Addendum 5

December 2, 2022

SUCF 081058-00 Upgrade Elevators - Campus Wide at SUNY New Paltz, 1 Hawk Dr.
New Paltz, NY 12561

Prepared by MDSzerbaty Associates 307 Seventh Avenue, Suite 1501, New York, NY 10001 and
IAQ Systems Inc., 555 Eighth Avenue, Suite 1502, New York, NY 10018

1
T006

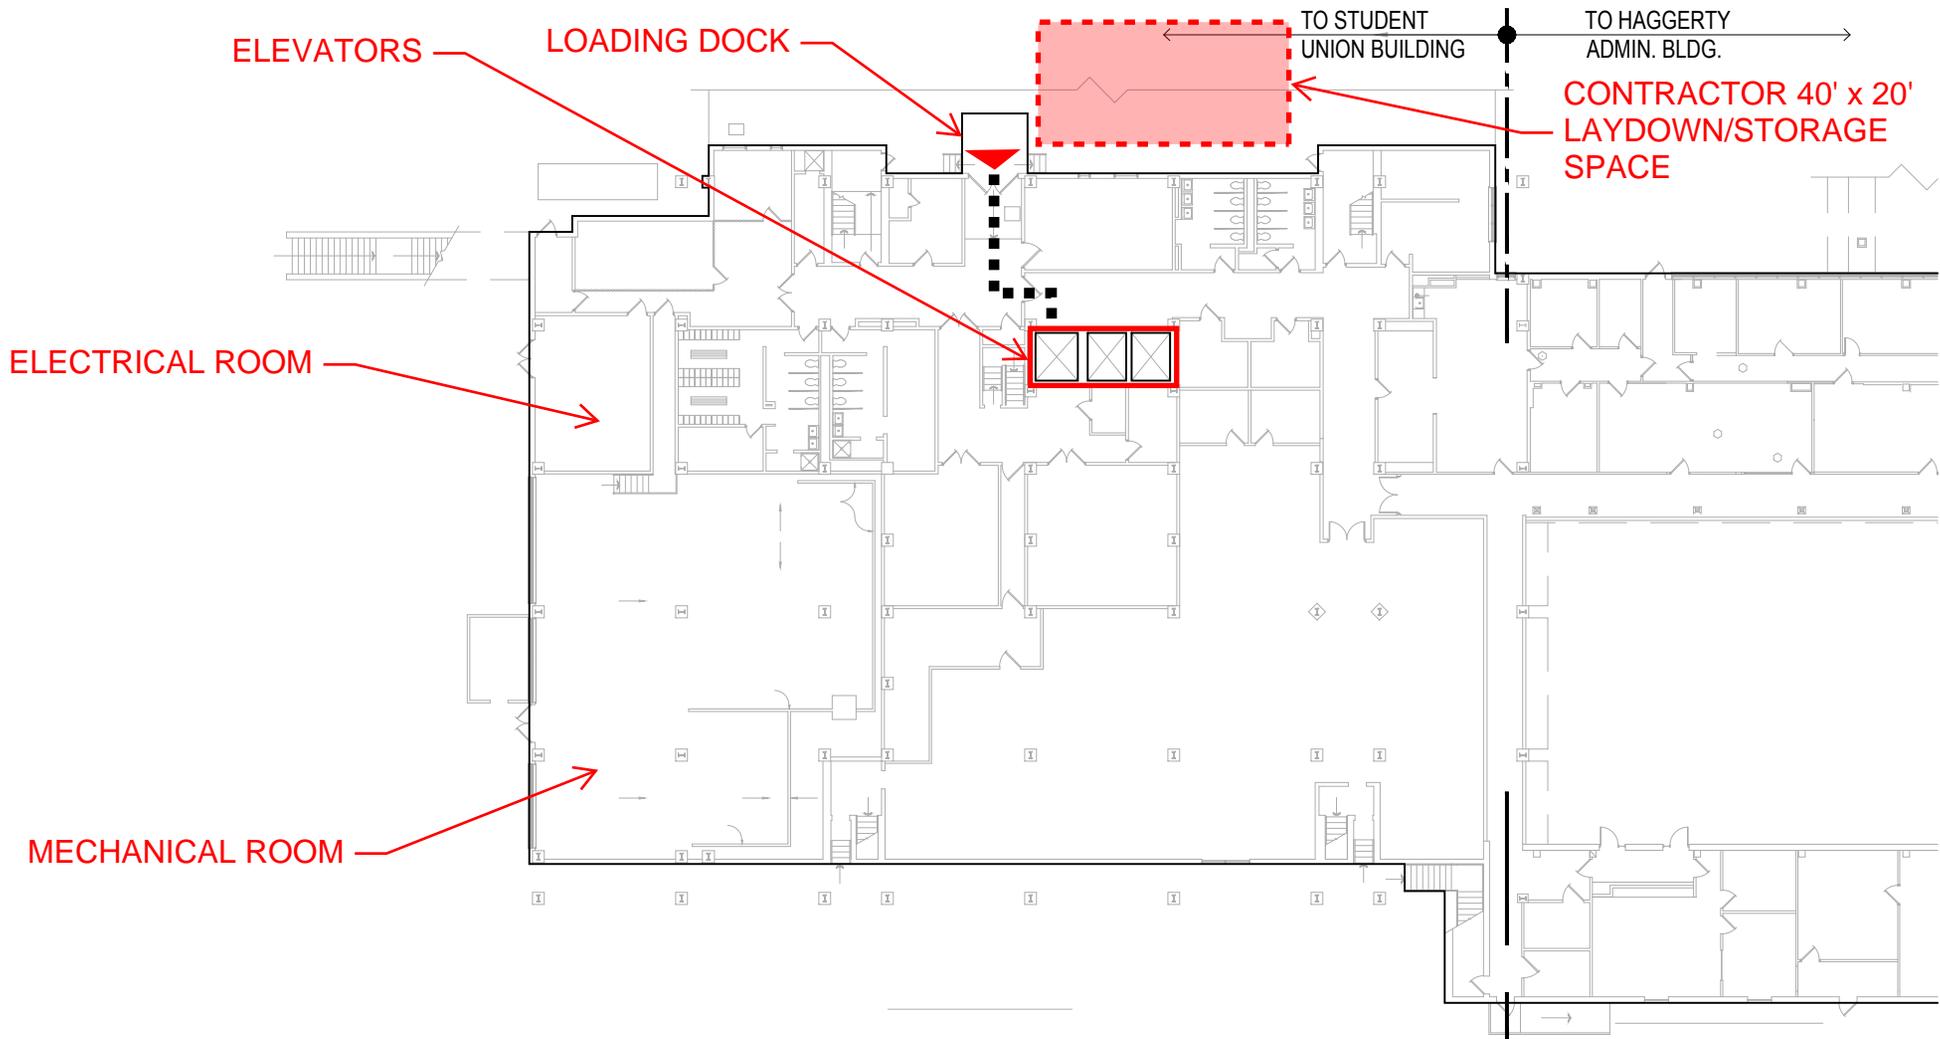
Replace drawing 1 with attachment 28.

4 HVAC - SOJOURNER TRUTH LIBRARY GROUND FLOOR PART PLAN ELEVATOR RM (ELEVATOR 2)
 STL-M107 SCALE: 1/4" = 1'-0"

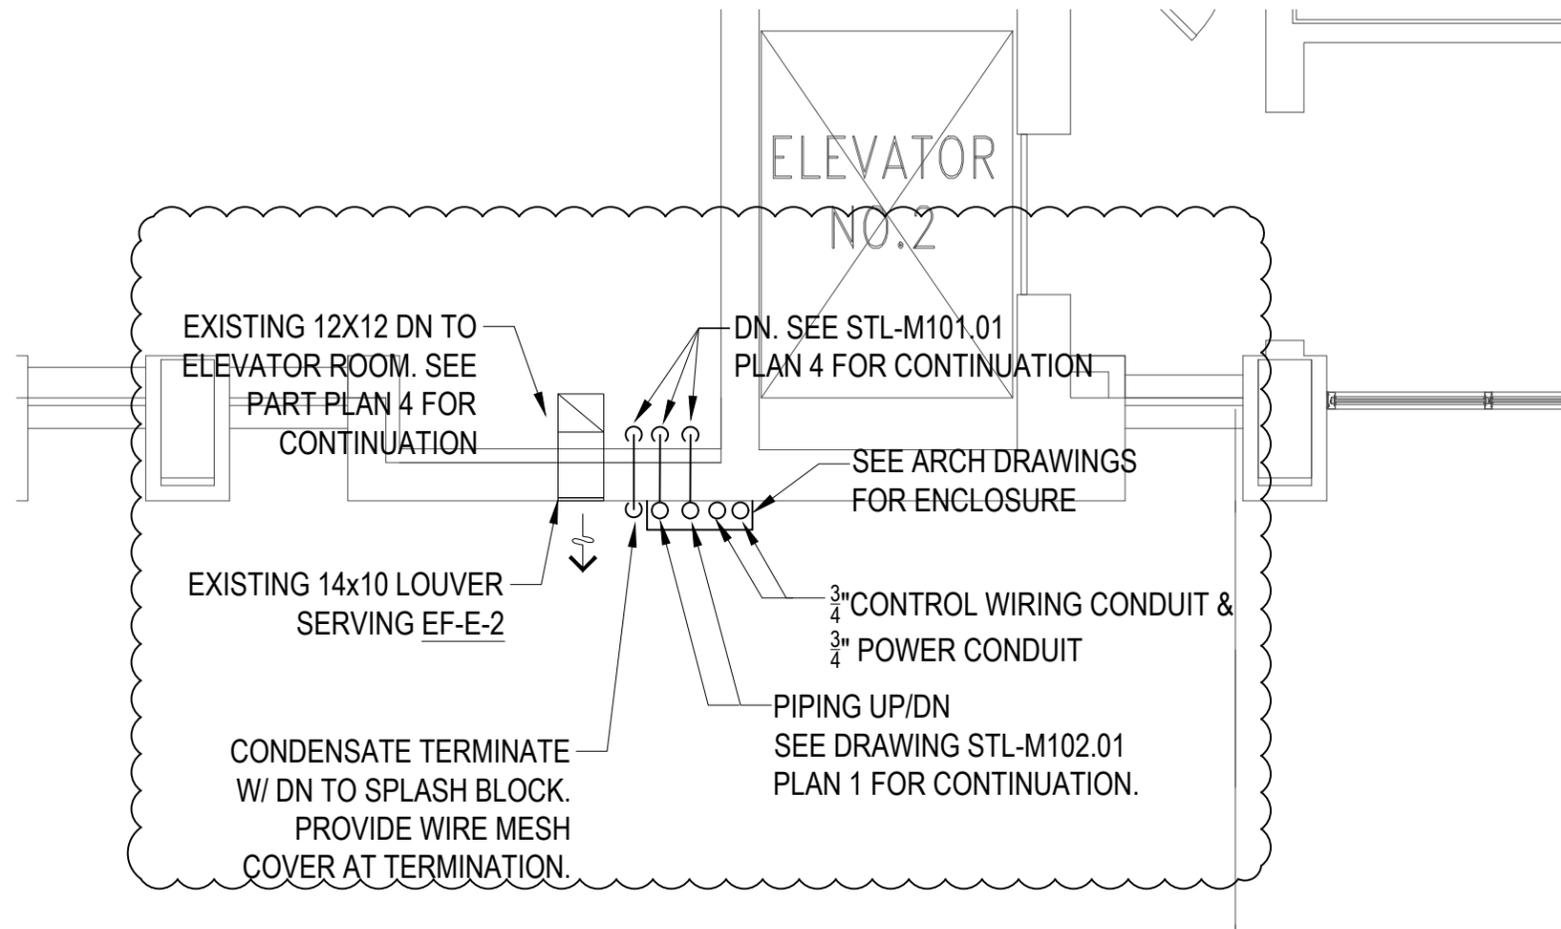
Revise drawing 4 as shown on attachment 35.

6
STL-M101

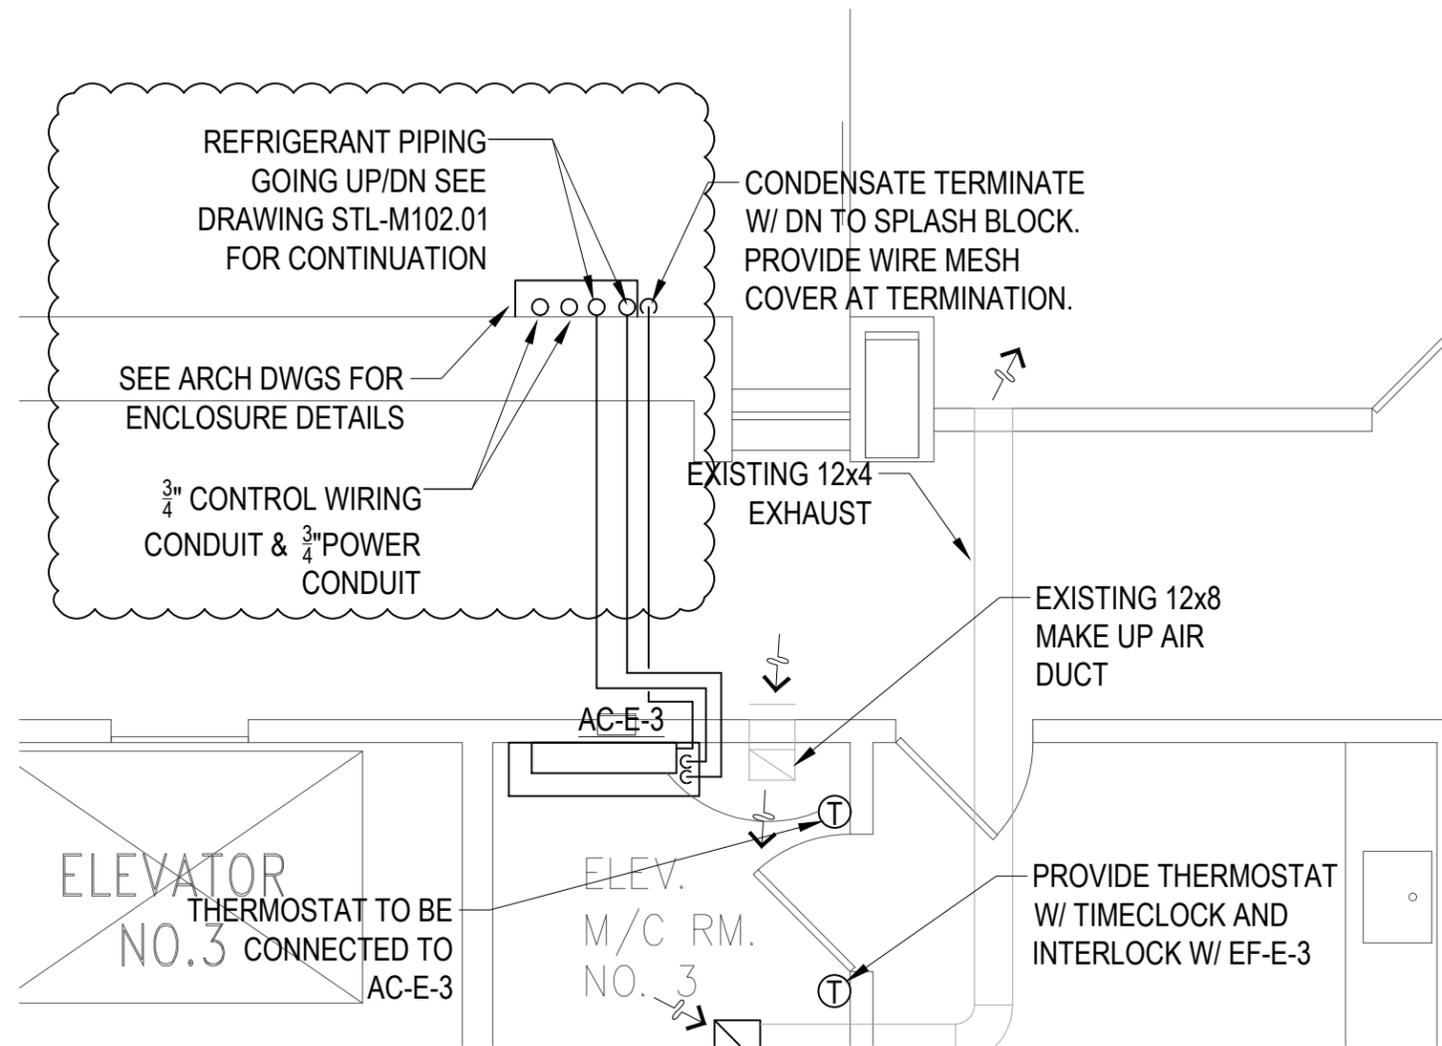
Revise drawing 6 as shown on attachment 36.

5
STL-M101

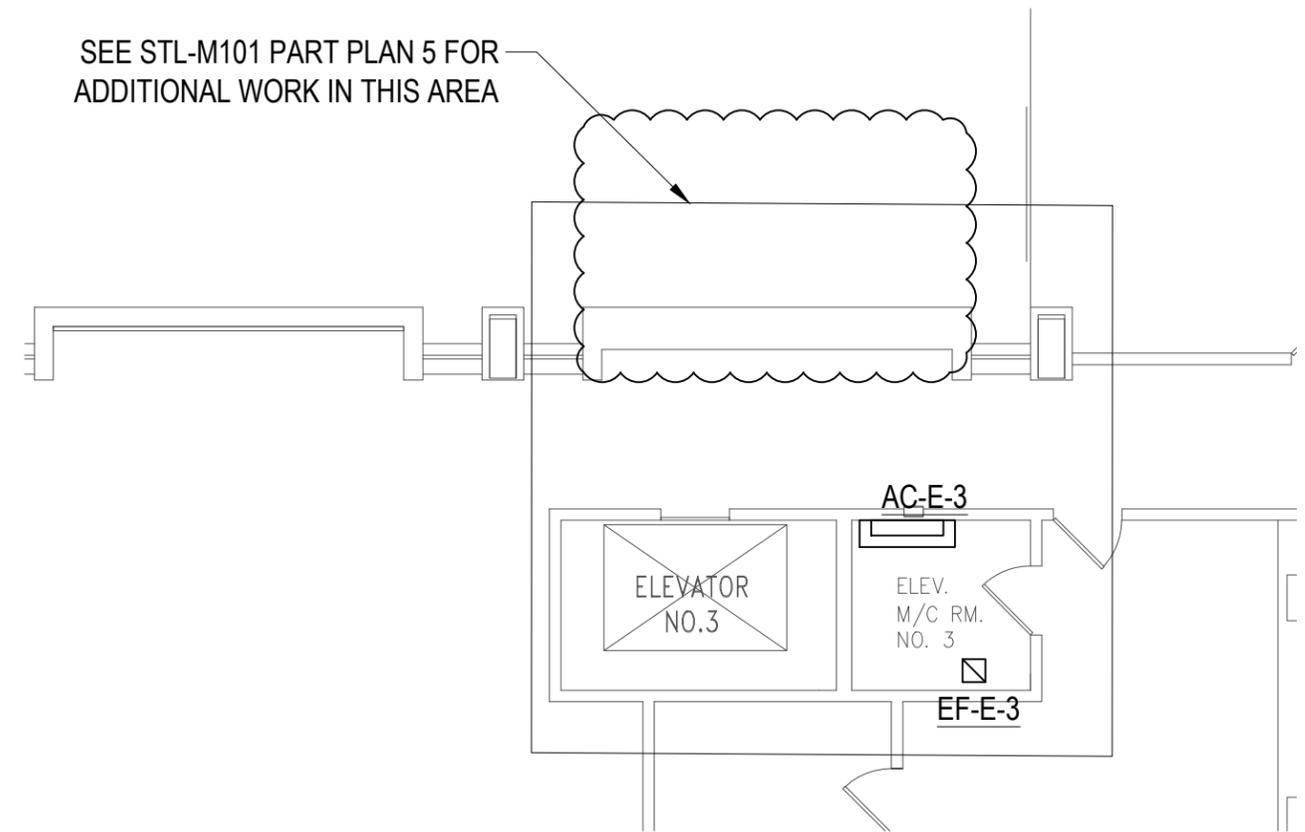
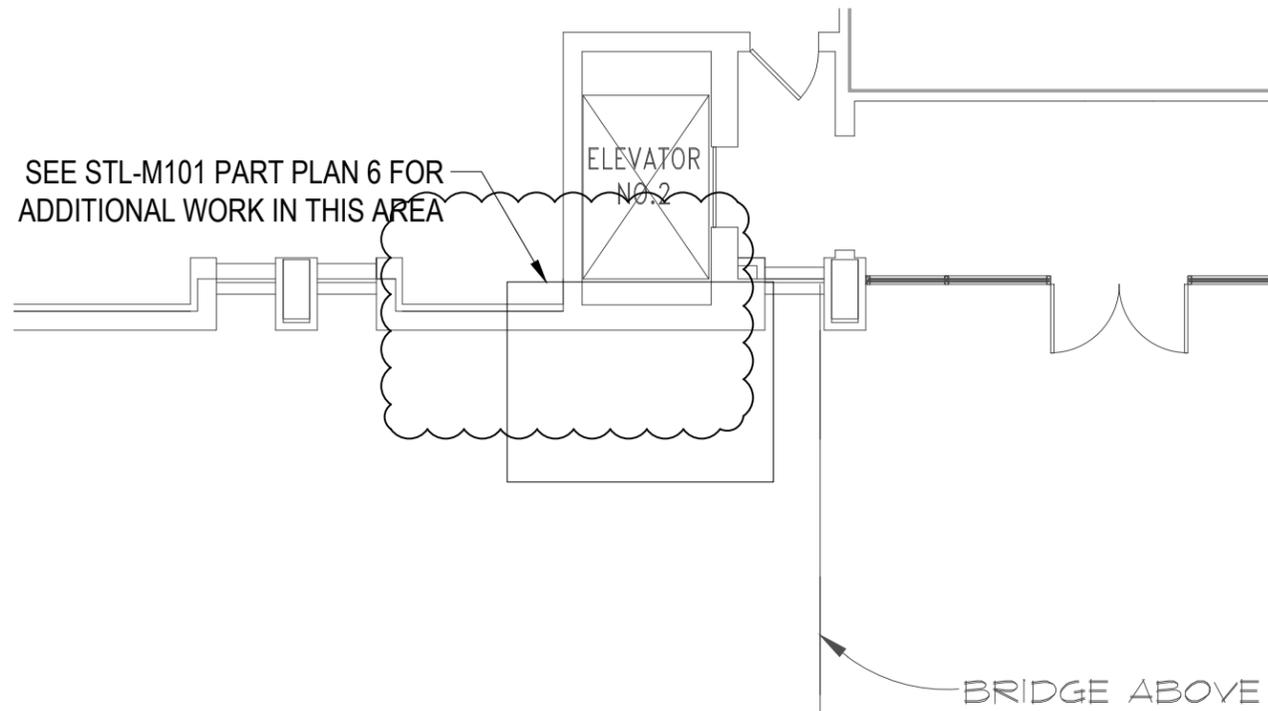
Revise drawing 5 as shown on attachment 37.

1 HVAC - SOJOURNER TRUTH LIBRARY ROOF PART PLAN
 STL-M102 SCALE: 1/8" = 1'-0"

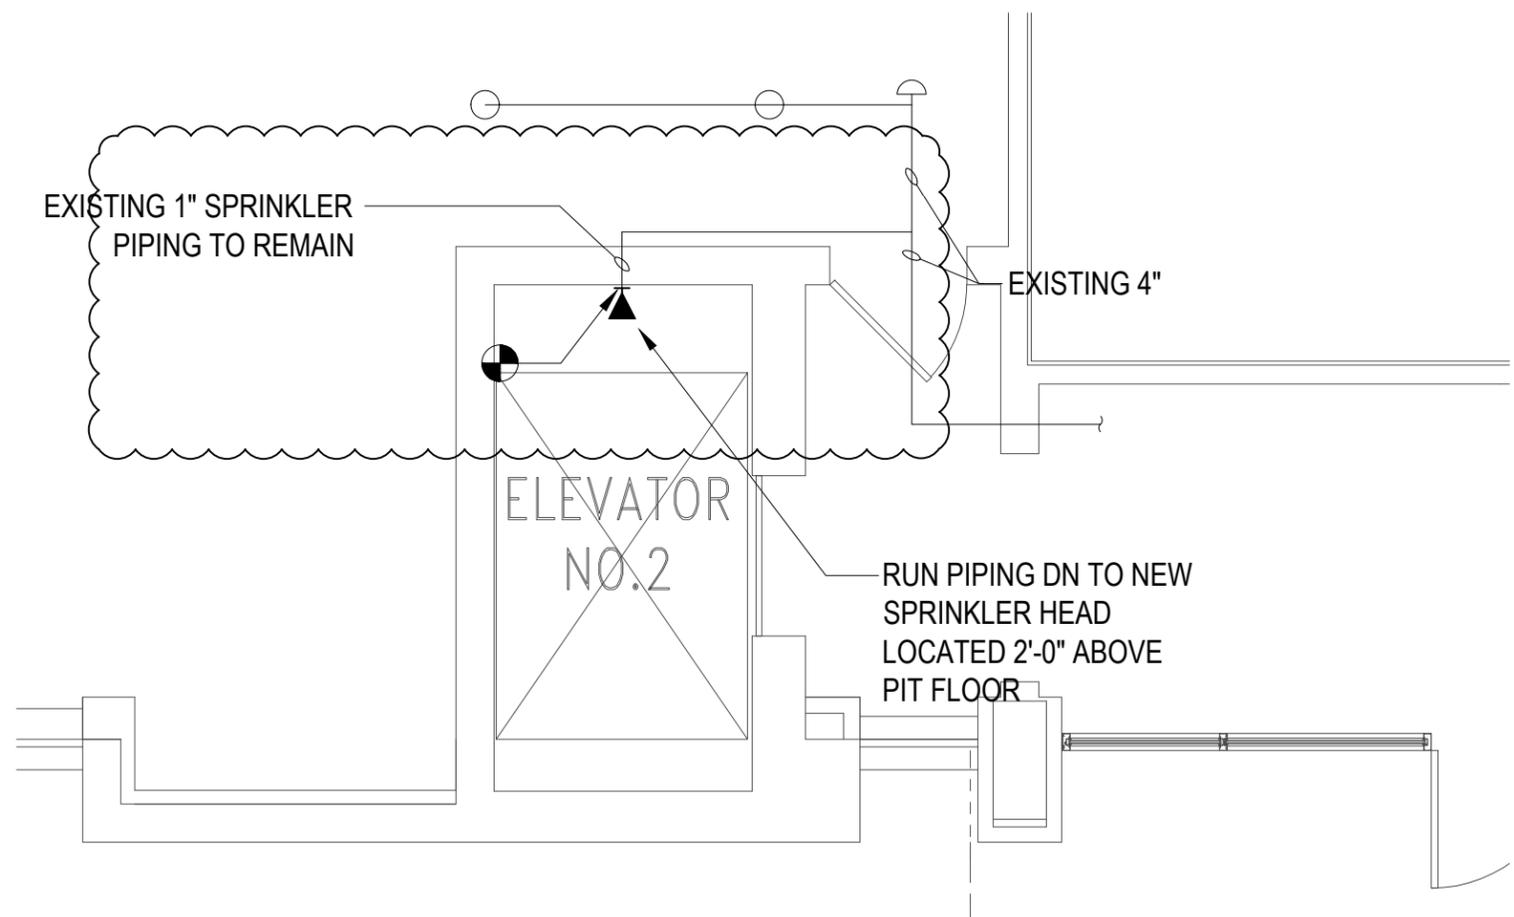
Revise drawing 1 as shown on attachment 38.

4
STL-FP101

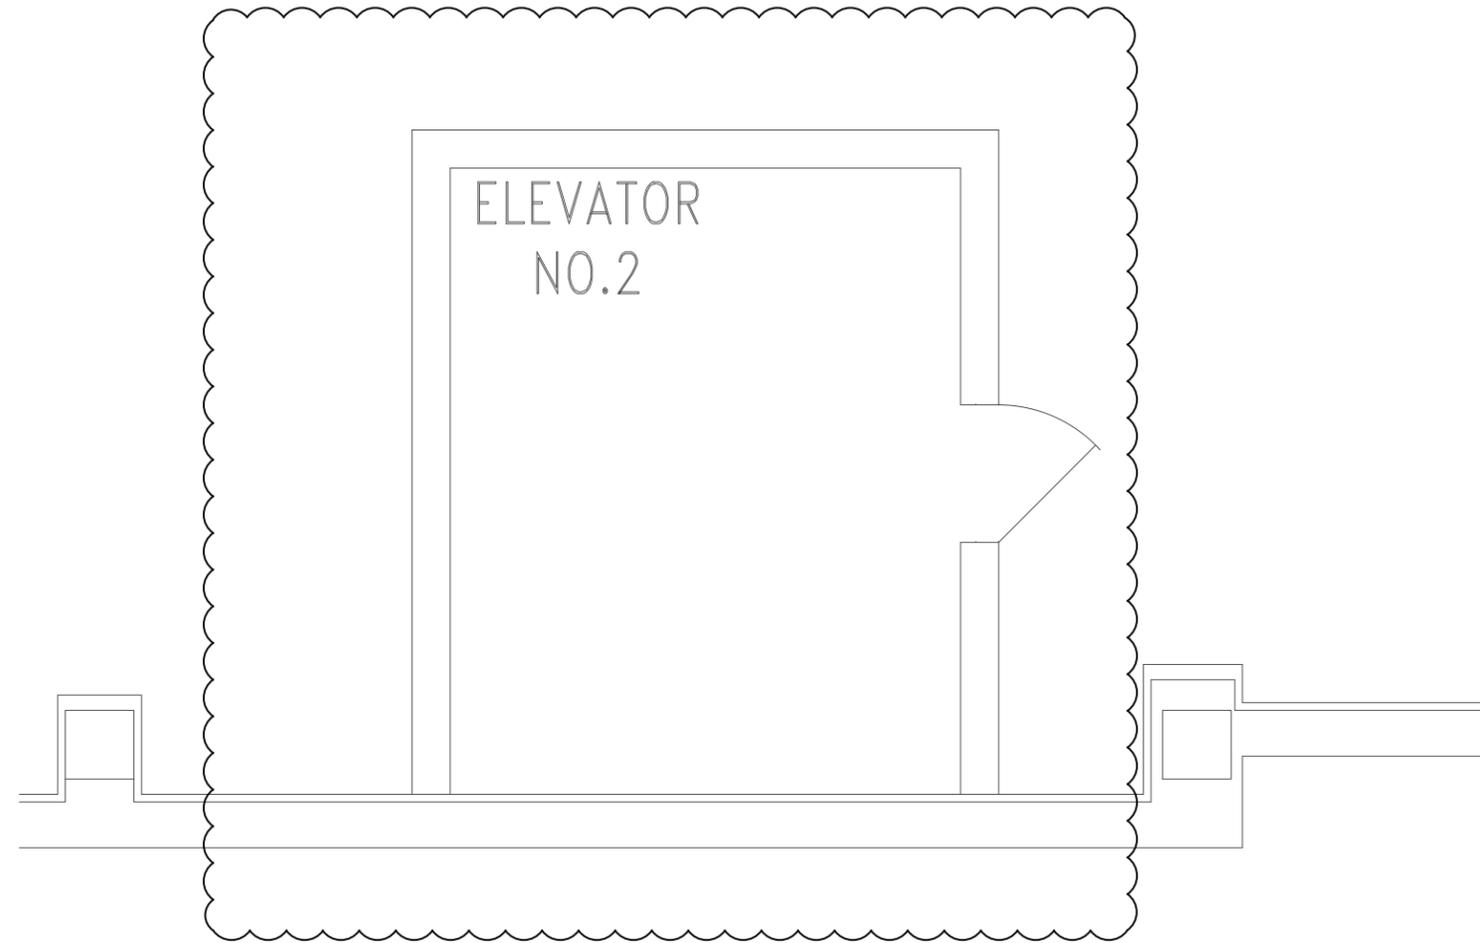
Revise drawing 4 as shown on attachment 40.
